CITY PLAN COMMISSION STAFF REPORT

Bodhi Residential Development

CD-CPC-2021-00100 -Rezoning with a plan

Report Date: October 15, 2021
Case Number: CD-CPC-2021-00100
Project: Bodhi Residential Development

SITE PLAN

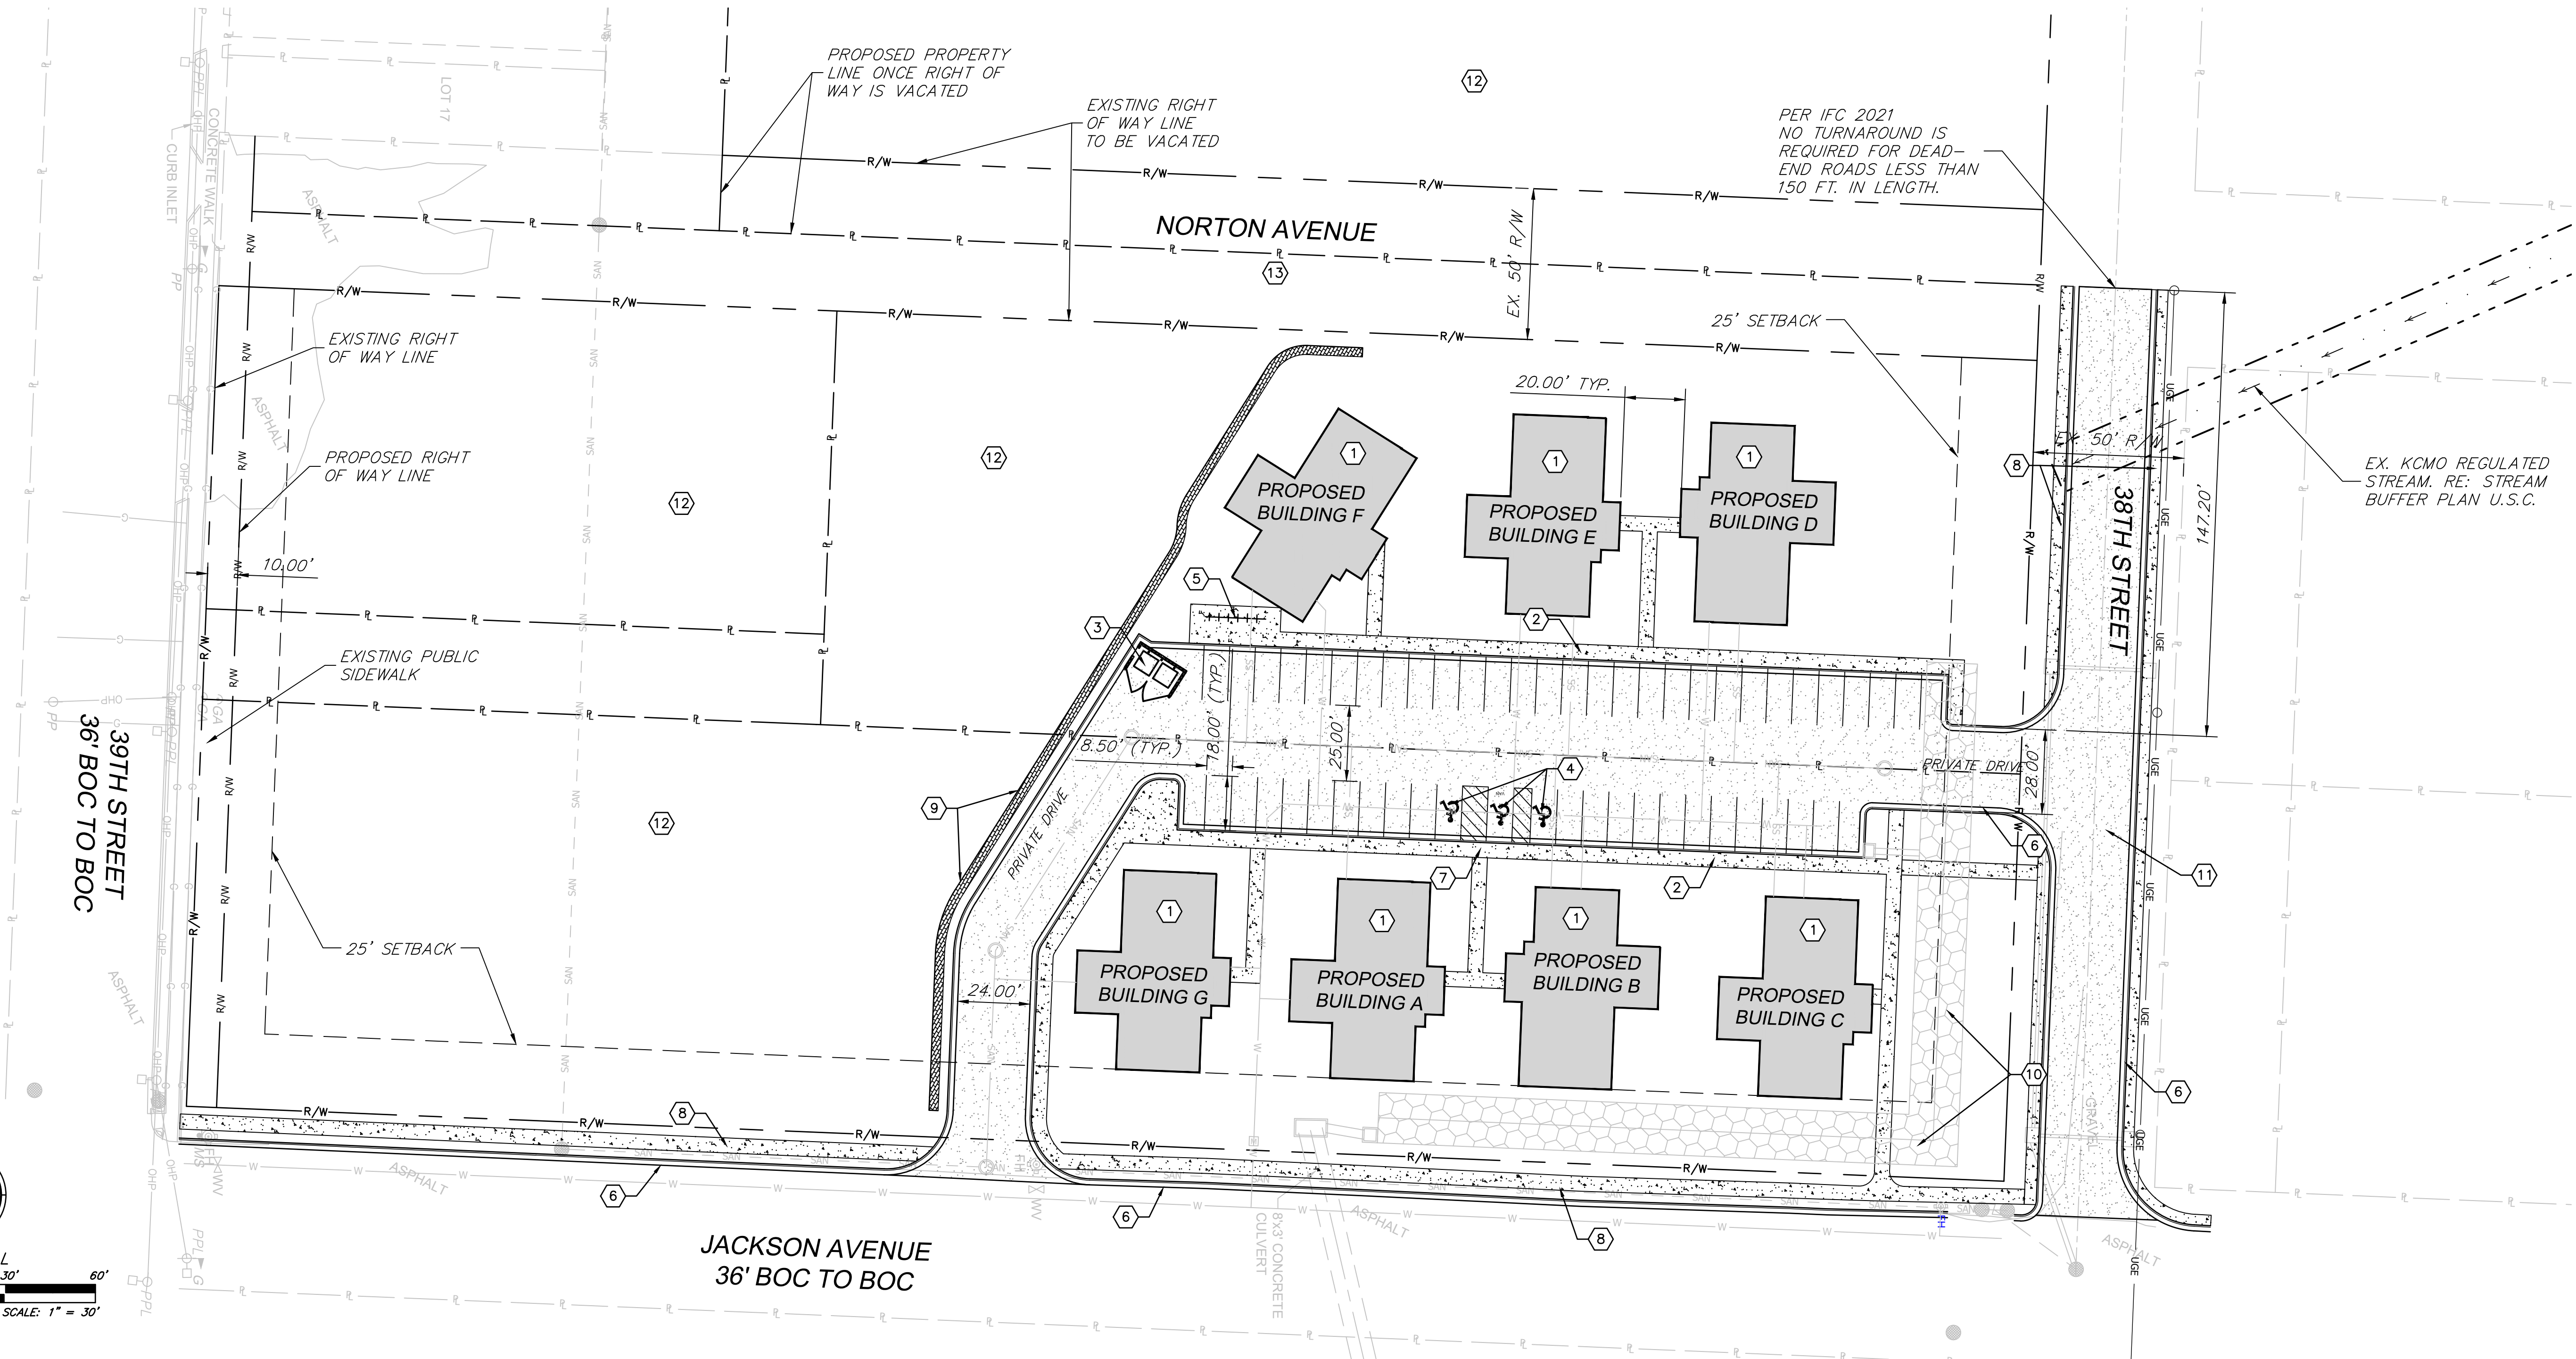
15. The proposed radius at 38th Street will need to be revised (increased). It looks like some utility work will be needed to make this happen. (10/08/2021)
